INLAND WETLANDS AND WATERCOURSES COMMISSION

**AGENDA
DECEMBER 4, 2025**

Application 25-25 15 Plum Tree LLC-Permit approval to construct a 3 story apartment building & 9 attached townhouses, a retaining wall, subsurface stormwater detention system, level spreader, sidewalks and storm drainage within a regulated area at 5 & 15 Plumtree Lane.

SITE PLAN

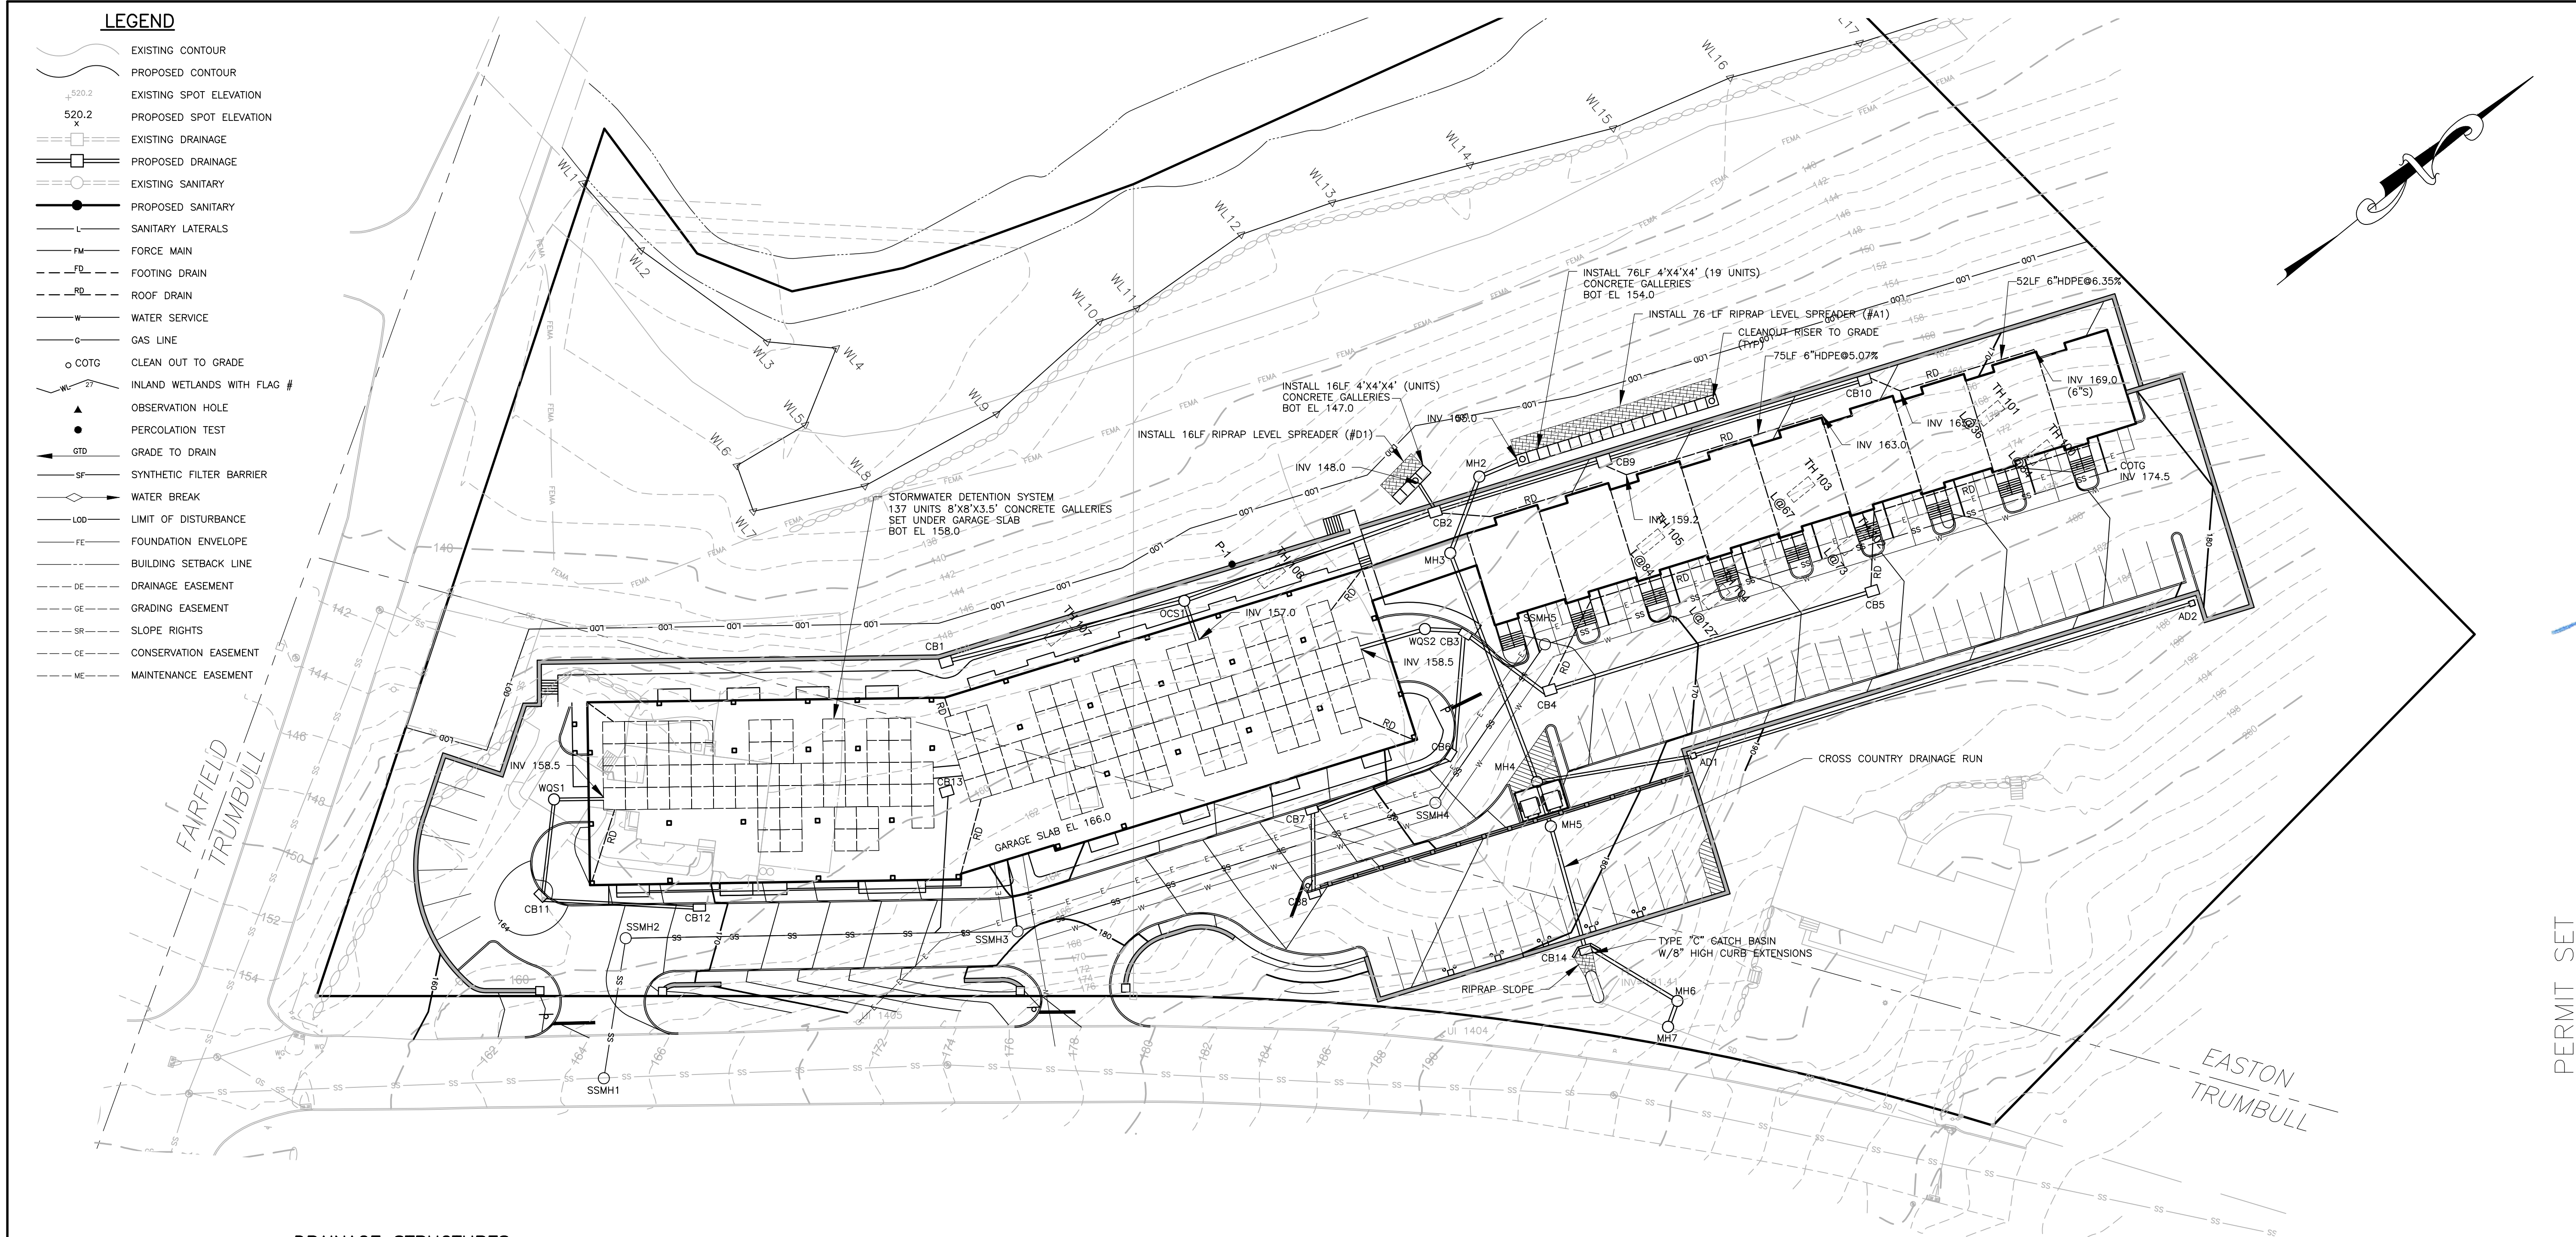
It is unclear what the 200-foot Mill River Setback is and who regulates it, but on Site plan Sheet 2.1, however, there is significant amounts of disturbance planned within that area. Additionally, no proposed final grades or grading plan was proposed for review. Grading is a significant impact to the Site during development and post-construction. We recommend that these details be supplied as part of this application for review and that both Engineering and Planning & Zoning Departments in both municipalities review this application, as it relates to their purview.

The Site plans such as Sheet 2.1 should remove *Conservation Easement* and other descriptions from the Legend if they do not exist on the Site. This creates confusion or gives the impression that information is missing or incorrect on the plans.

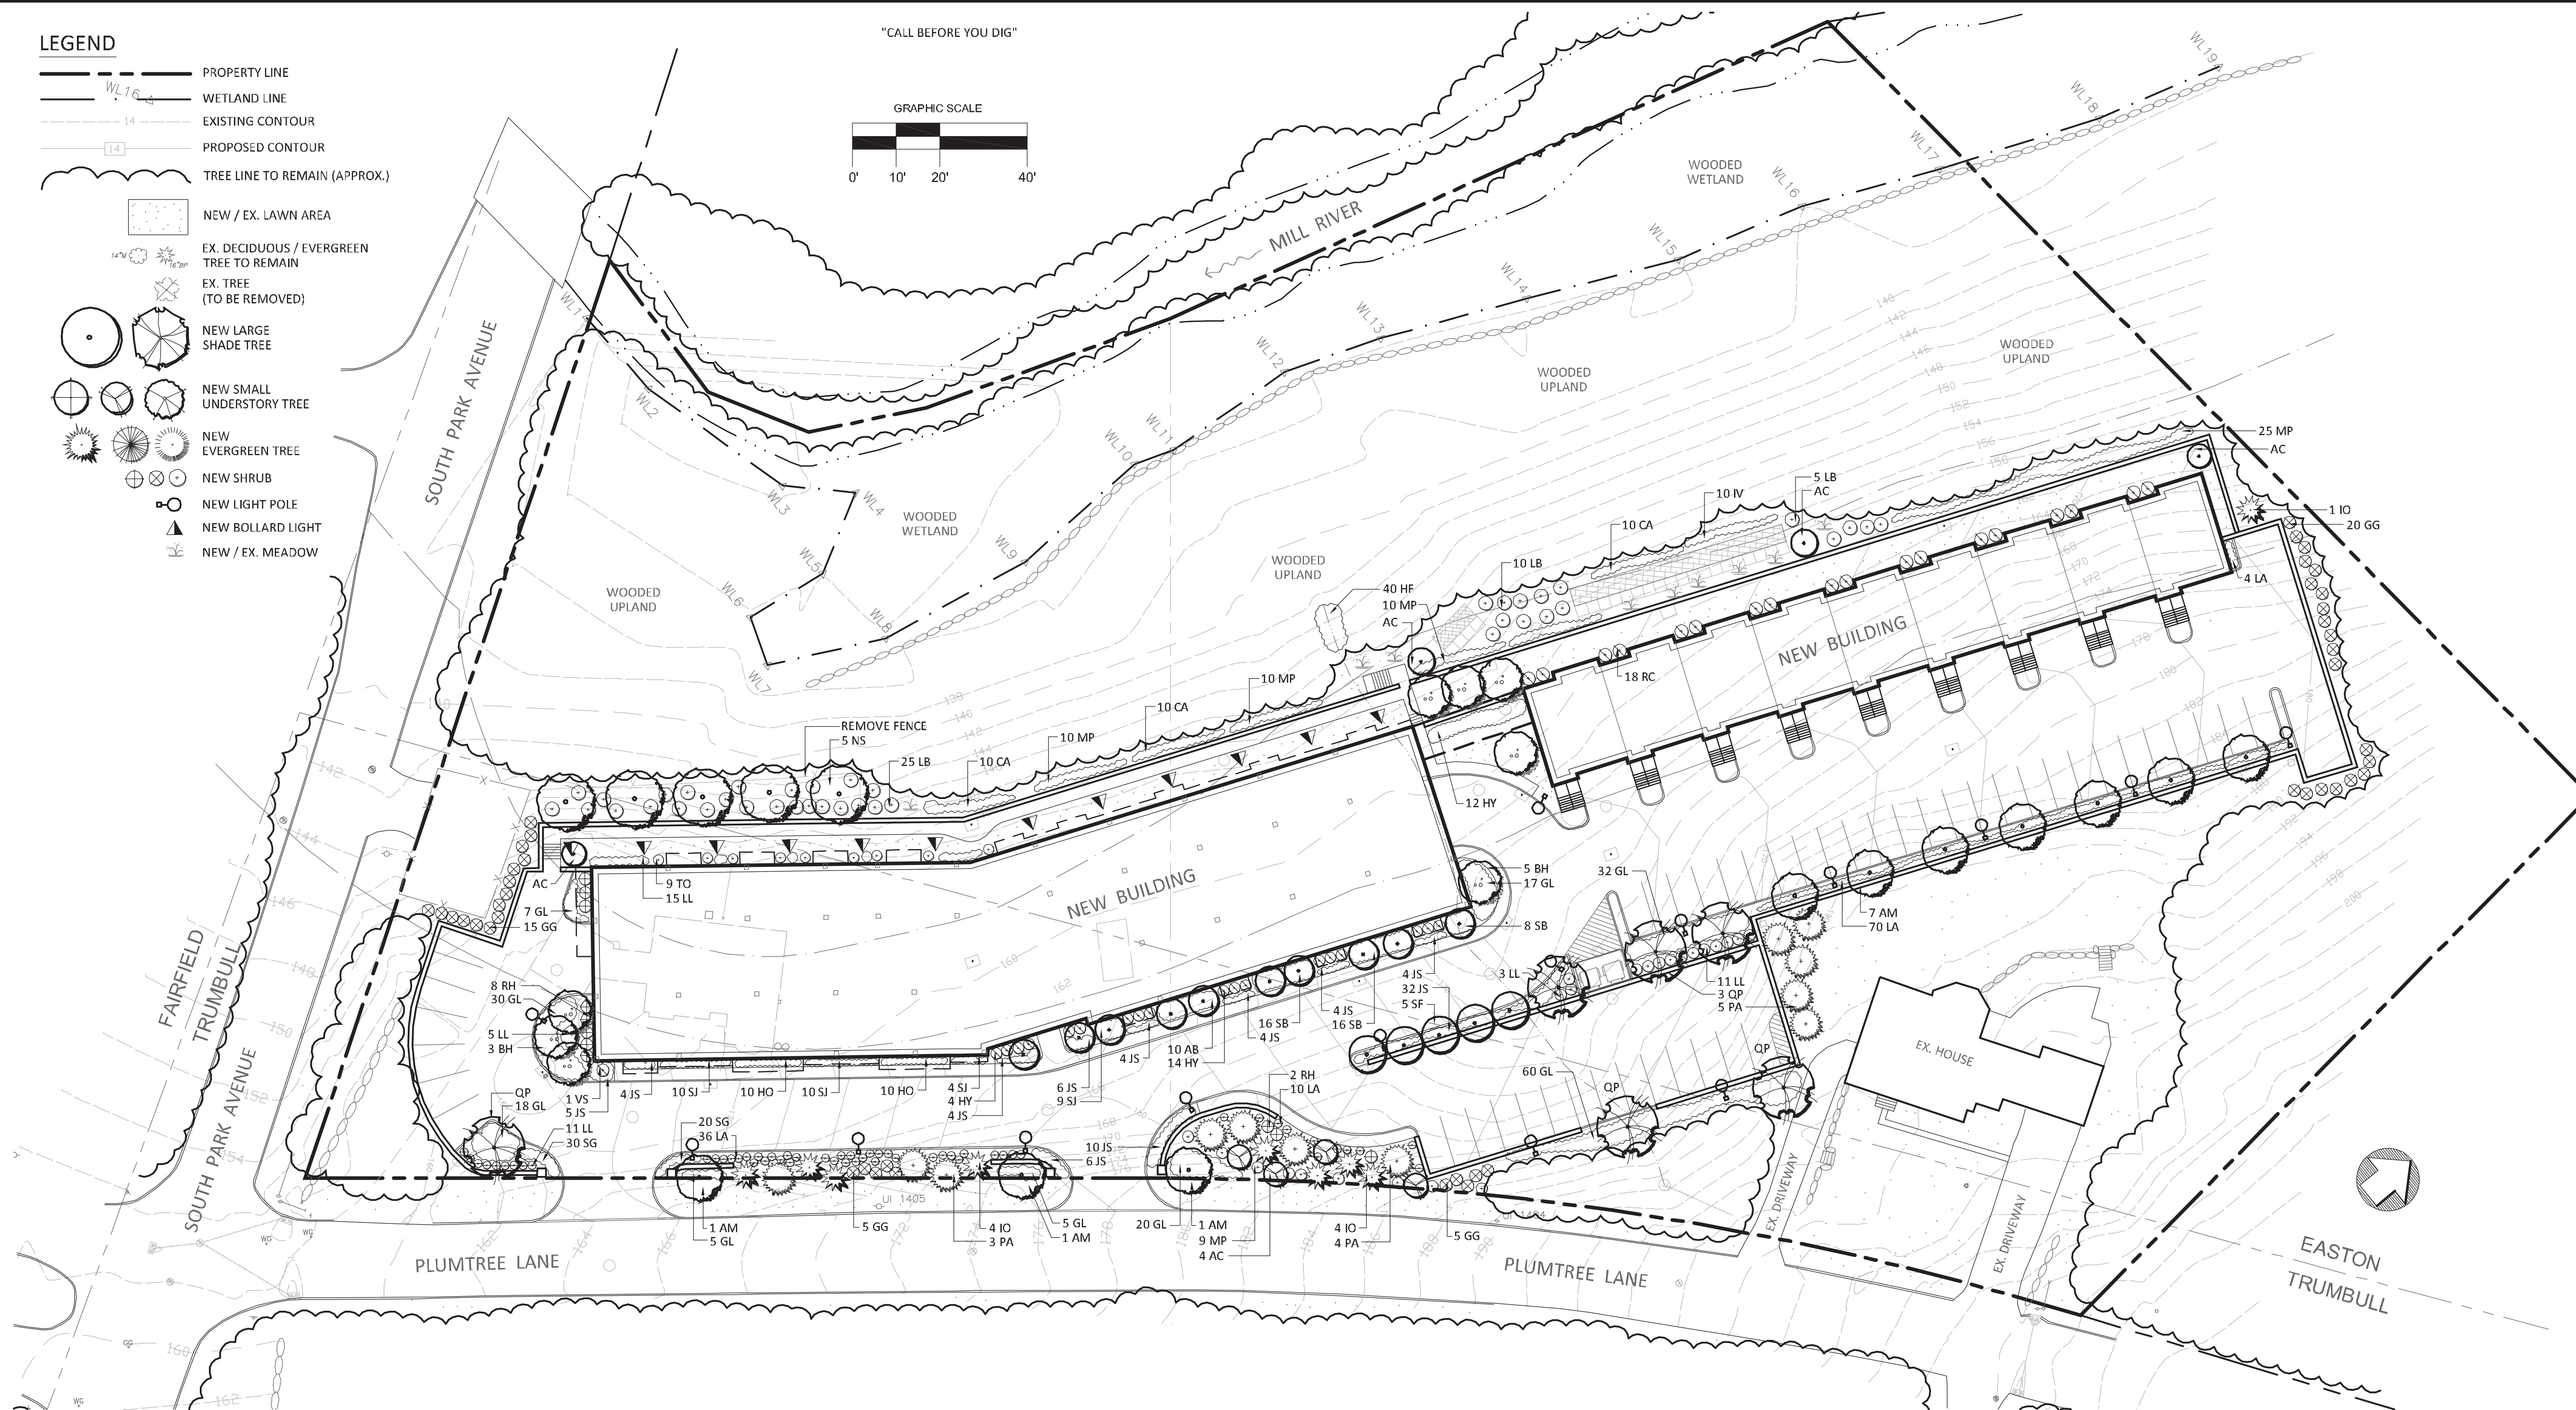
A landscaping plan was also submitted for the residential development area. This plan includes native species such as Black Gum (*Nyssa sylvatica*), Pin Oak (*Quercus palustris*), and Switchgrass (*Panicum virgatum*); however, a total of 54 Green Giant/Emerald Green Arborvitaes (*Thuja spp.*)

are proposed for screening, and these species do not provide the same physical or ecological benefits as native vegetation. It is recommended that the applicant reconsider substituting at least half of these with native evergreens that offer comparable screening functions, such as Eastern Red Cedar (*Juniperus virginiana*), American Holly (*Ilex opaca*), native spruces or other similar species. While not required, but as a result of the Site being mapped by CTDEEP's NDDDB, it is recommended that all proposed planting plans utilize native trees and shrubs to enhance habitat value and ecological function for both terrestrial and aquatic wildlife.
